C2C return loss

Piers Dawe

Some related issues with C2C spec

Showing various return loss limits

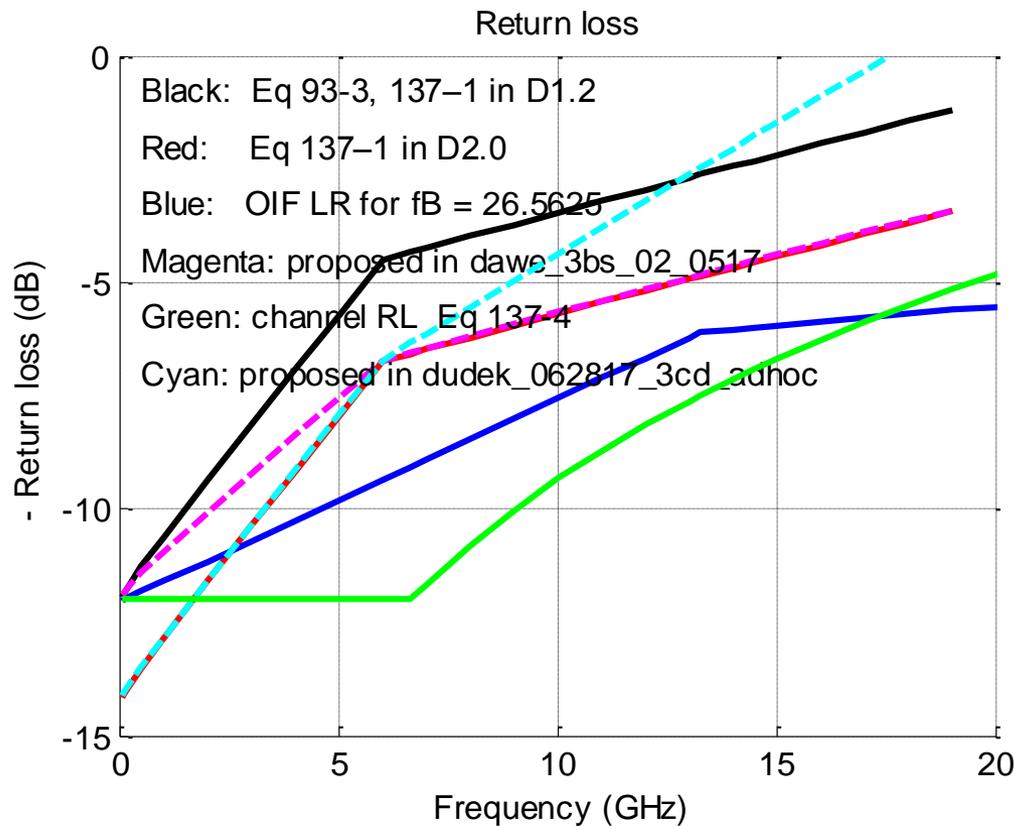
Nominal return losses: channel and OIF
at IC, others at test fixture

Adjusting for test fixture IL but not its RL

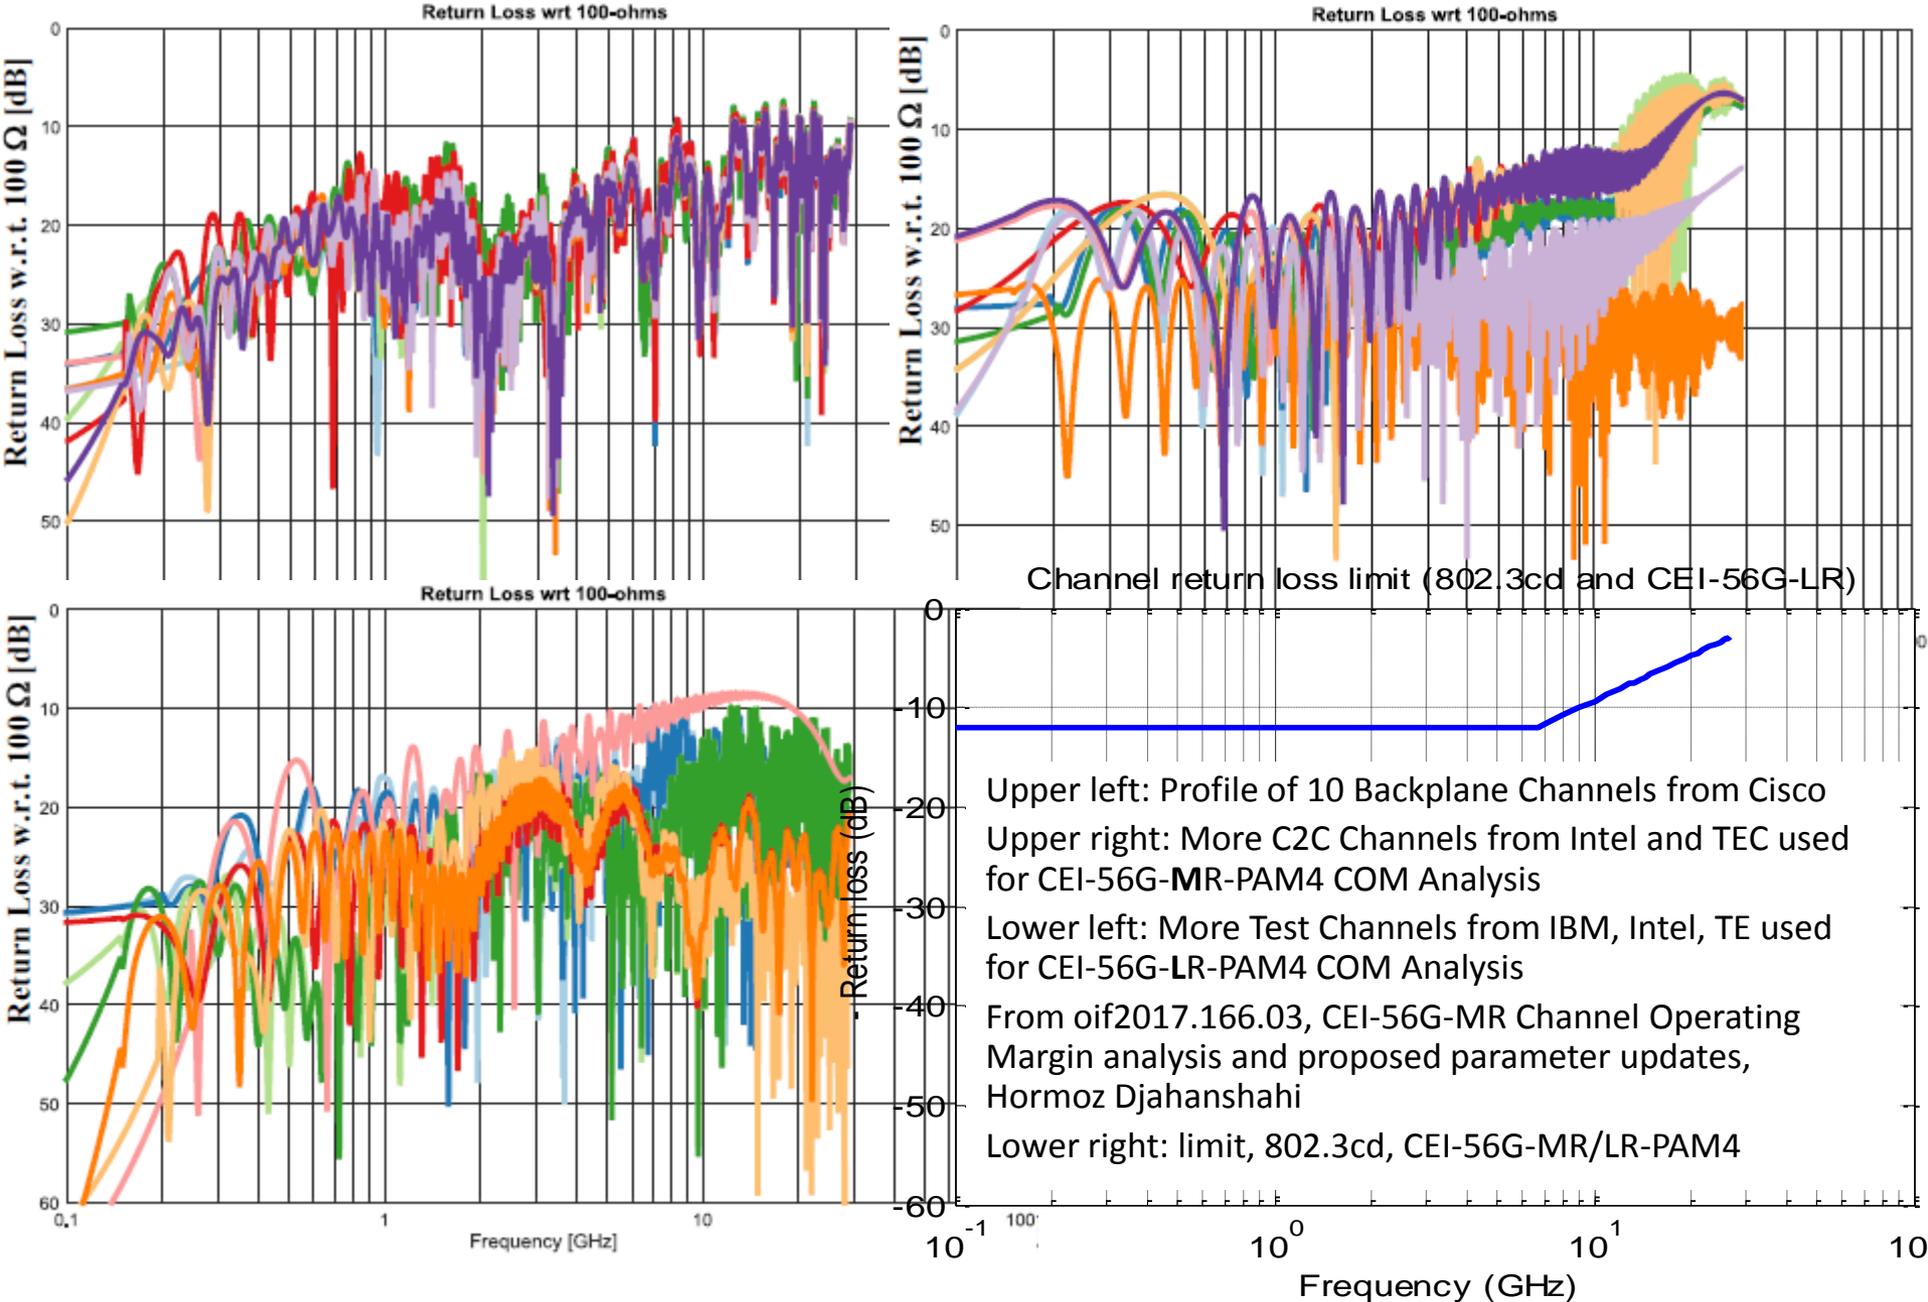
- Compare previous slide
- Red and cyan are too tight at low f
- Cyan is too loose at high f
- Black is too loose at mid f
- Green – channel (compare next two slides)
